04V-564
(4 pages)

On November 22, 2004, Honda Motor Co., Ltd. (HMC) determined that a defect relating to motor vehicle safety exists in the motor vehicles listed below, and is furnishing notification to the National Highway Traffic Safety Administration in accordance with 49 CFR Part 573 Defect and Noncompliance Reports.

<u>Make/Model</u>	<u>Description</u>	<u>VIN/Dates of Manufacture</u>
Honda VTX1800C	Certain 2002 model year	1HFSC46**2A000001 – 1HFSC46**2A010902
Honda VTX1800R	Certain 2002 model year	1HFSC49**2A100001 – 1HFSC49**2A000990

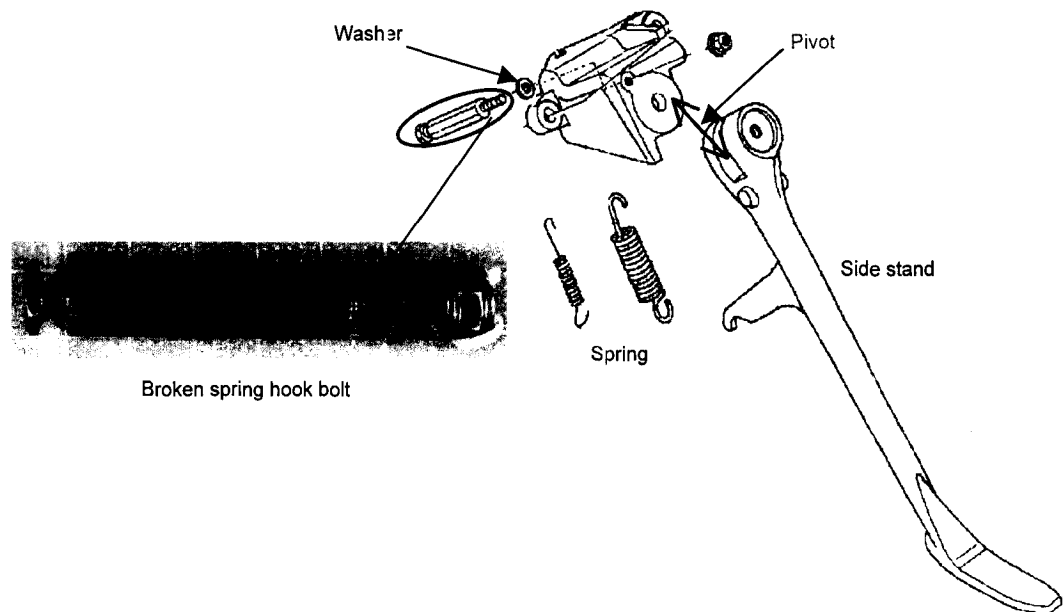
The washer for the side stand spring bolt does not have sufficient hardness and may deform, which could cause the bolt to flex and eventually break during side stand operation. In limited circumstances, a retracted side stand could drop while riding, possibly activating the side stand ignition cut-off system. If the ignition is cut, the engine will stall without warning, which could cause a crash.

The side stand is held in the down or the retracted position with a spring and spring hook bolt. The washer installed on the spring hook bolt does not have sufficient hardness and may deform, which could lead to flexing of the bolt. Stresses from side stand operation could eventually cause the bolt to break during side stand operation and, generally, the side stand will no longer remain in a retracted position, which is obvious to the operator. However, if the side stand pivot is corroded, the corrosion may prevent the side stand from falling back down after being retracted. In this case, riding on rough roads could cause a retracted side stand to drop while riding. These motorcycle side stands are equipped with an ignition cut-off system. If the side stand drops while riding, there is a possibility the engine could stall without warning and cause a crash.

The owners of all affected vehicles will be notified by mail and asked to take their vehicle to an authorized Honda dealer. The dealer will install an improved washer and a new spring bolt and nut, free of charge.
